Video Products Technical Bulletin 30-2008-022

DATE: **March 17, 2008**SUBJECT: **REUSE IC101 WHEN REPLACING THE A BOARD**MODEL: **PVM-20M4U**SERIAL NO: **ALL**

Figure 1

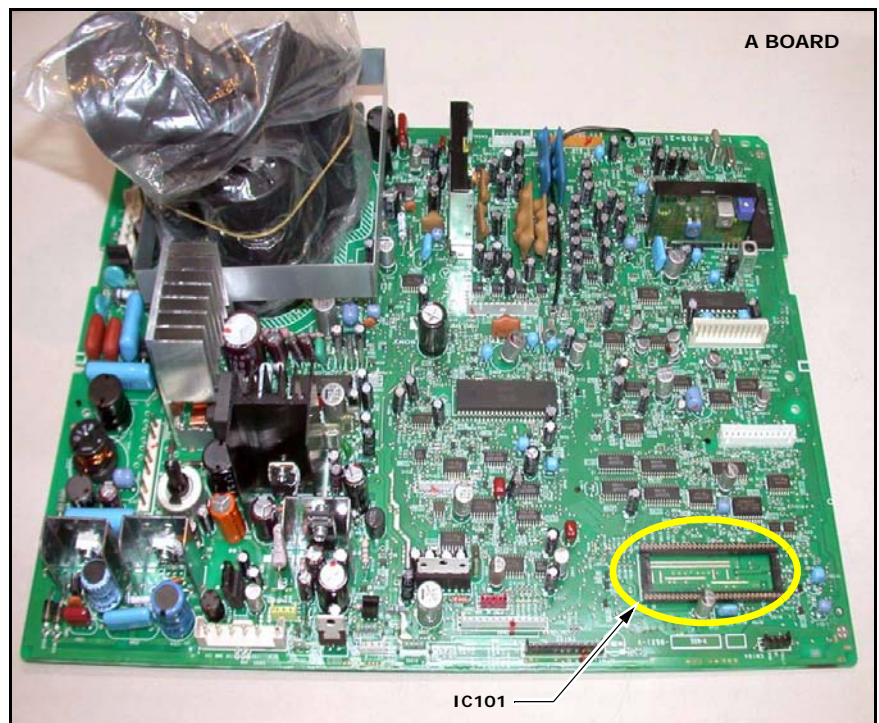
When you replace the A board (A-1298-559-A), remove IC101 from the former board and install it on the new board.

The new A board does not contain IC101, and IC101 is no longer available as a service part. (See Figure 1.)
